**STATE OF CALIFORNIA
STATE WATER RESOURCES CONTROL BOARD**

Cleanup and Abatement Order No. R9-2025-0014

PETITION FOR REVIEW

Figure 1: Location of Properties

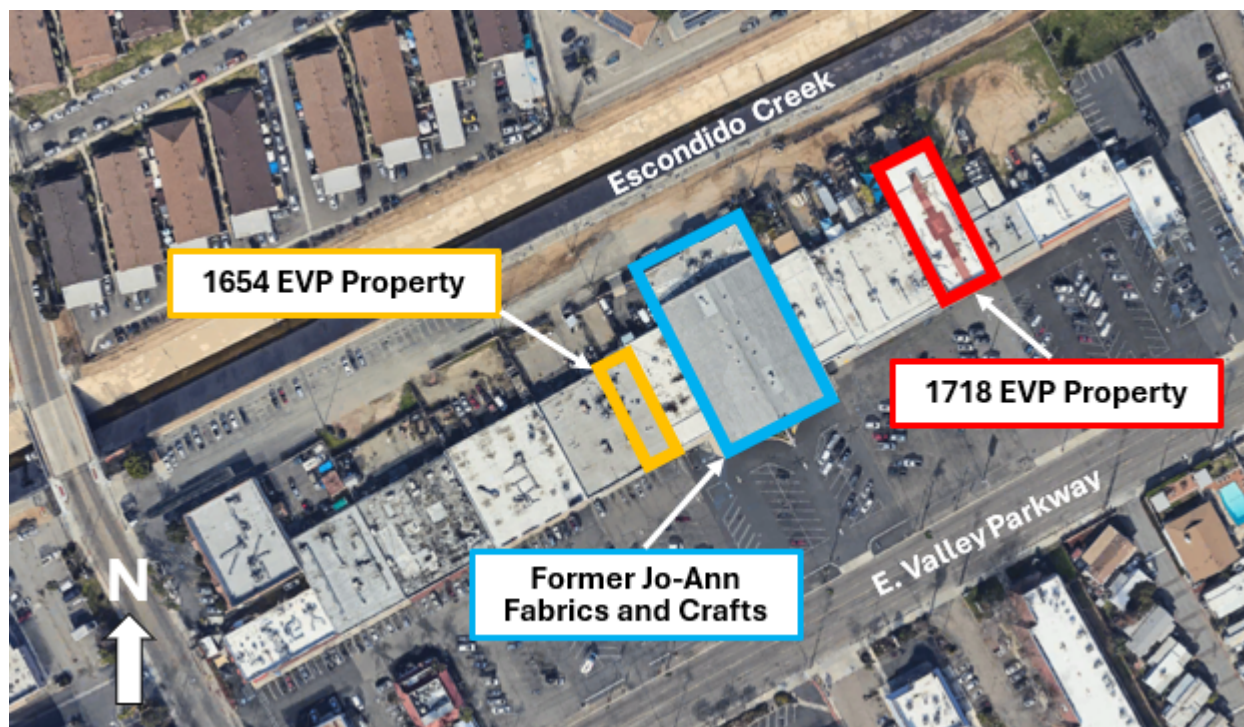
2j	Figure 1	Figure 1 of the TCAO improperly identifies the boundary of 1654 EVP to include 1652 EVP, the suite located adjacent to the west-southwest of 1654 EVP. This illustrates a lack of San Diego Water Board staff's understanding of site conditions.	<p>San Diego Water Board staff disagree with the comment. The purpose of Figure 1 is to illustrate the approximate locations of 1654 EVP and 1718 EVP relative to the former Jo-Ann Fabrics and Crafts (1680 EVP). The boundaries are shown more accurately on Figures 2 to 4, which show the results of the passive soil vapor survey. These boundaries were drawn based on Figure 1 of IES's November 2, 2022, passive soil vapor technical memorandum.</p> <p>San Diego Water Board staff have, however, revised the TCAO in response to this comment to refine the property boundary of 1654 EVP. See Figure 1.</p>
2k	Finding D	Now there is data available that indicates a release has not occurred at 1654 EVP, but the TCAO ignores these facts. This illustrates a lack of San Diego Water Board staff's understanding of site conditions or inherent bias against my client.	San Diego Water Board staff disagree with the comment. IES recommended that the San Diego Water Board provide a "no further action" determination for 1654 EVP based on the results from the (1) February and March 2022 site investigation to evaluate soil, soil vapor, and groundwater conditions at the Site, and (2) September

Comment No.	TCAO Section	Comment Summary	San Diego Water Board Staff Response
			<p>2022 passive soil vapor survey to evaluate the source(s) and lateral extent of chlorinated solvents in soil vapor beneath the Site. San Diego Water Board staff disagreed with this recommendation.</p> <p>San Diego Water Board staff have, however, revised the TCAO in response to this comment to provide clarity regarding this finding. See Findings D.3.viii and D.3.x.</p>
2l	Finding D	<p>There is no indication in the TCAO that the administrative file regarding 1654 EVP was clean, illustrating the inherent bias that my client is being subjected to by San Diego Water Board staff.</p>	<p>San Diego Water Board staff disagree with the comment.</p> <p>On February 7, 2020, DEH issued an official notice to Guhn Kim recommending that he enroll in the Voluntary Assistance Program due to a potential release of PCE from the Suzy Cleaners facility. DEH's recommendation was based on review of the environmental reports described in Findings D.3.i to D.3.vii of the TCAO. On May 5, 2020, DEH issued another official notice to Guhn Kim providing responses to Procopio's April 22, 2020, comment letter regarding the Suzy Cleaners facility. Procopio's letter suggested that a source of the PCE may also be the former Ha's Cleaners located at 1718 EVP. DEH concurred with Procopio; however, DEH still maintained its February 7, 2020, position regarding the Suzy Cleaners facility.</p> <p>San Diego Water Board staff have, however, revised the TCAO in response to this comment to provide clarity regarding these findings. See Finding D.2.</p>

Figure 2: Passive Soil Vapor Analytical Results for cis-1,2-Dichloroethene

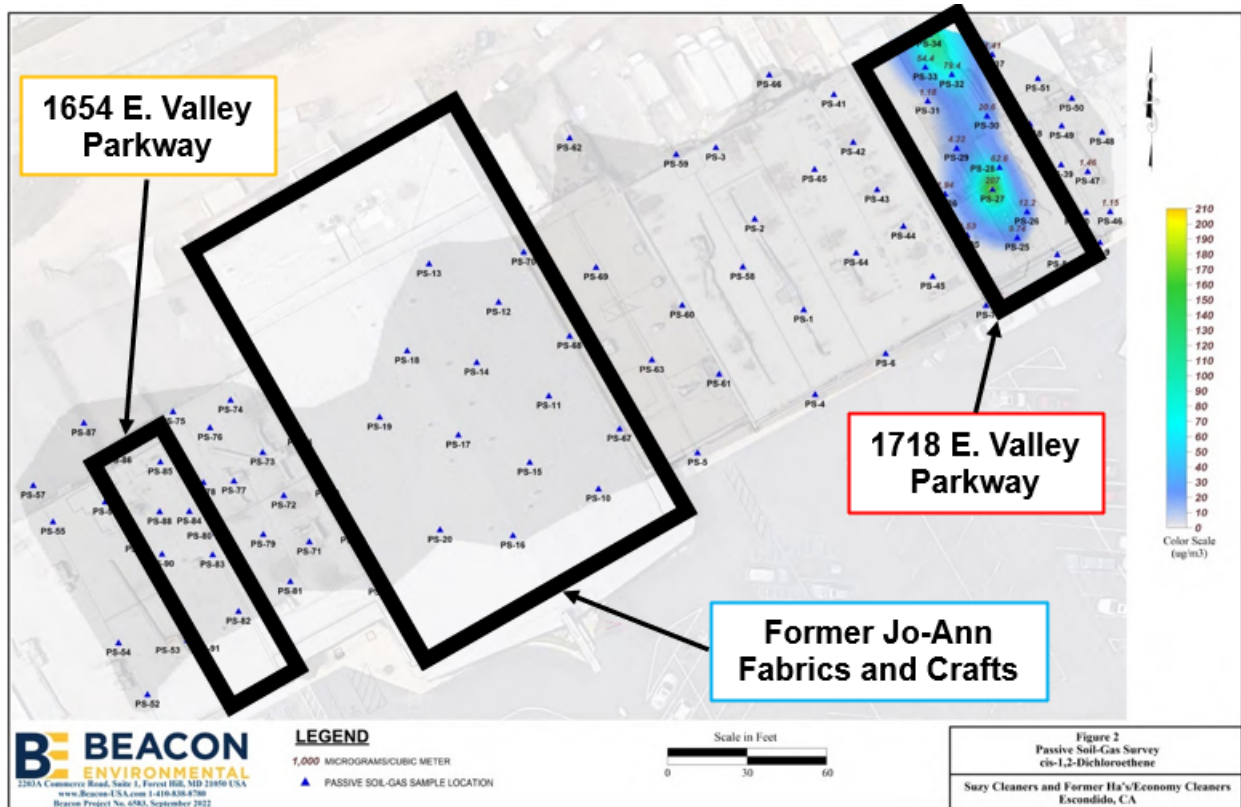
The results of this investigation indicate the existence of two separate releases of PCE, both from 1718 EVP. The presence of two distinctive oval shaped DCE patterns in close proximity to one another at the 1718 EVP location (Figure 2), illustrate where reductive dechlorination of PCE to TCE then DCE is actively occurring. As discussed, DCE very high mobility classification indicates that it does not linger in the environment and therefore the presence of DCE

In addition to the existence two DCE plumes in close proximity at 1718 EVP shown on Figure 2, Figures 3 and 4 illustrate the current locations and migratory path of the down (groundwater) gradient PCE plumes, the southern release having migrated approximately 350 feet to the PS-54 location, and the northern release having migrated approximately 100 feet to the PS-2/PS-58 location. The relative dispositions of the two down-gradient plumes in juxtaposition with the source area DCE footprint indicate that two separate releases took place at different times, and migrated with groundwater along similar trajectories and at similar rates to the west-southwest. Assuming consistent groundwater flow throughout the study area, the southern release from 1718 EVP would then pre-date the northern release. The migrating dissolved or DNAPL plumes would continue to emit TCE and PCE gas as they migrate with groundwater, which in turn would impact soil gas in proximal locations.
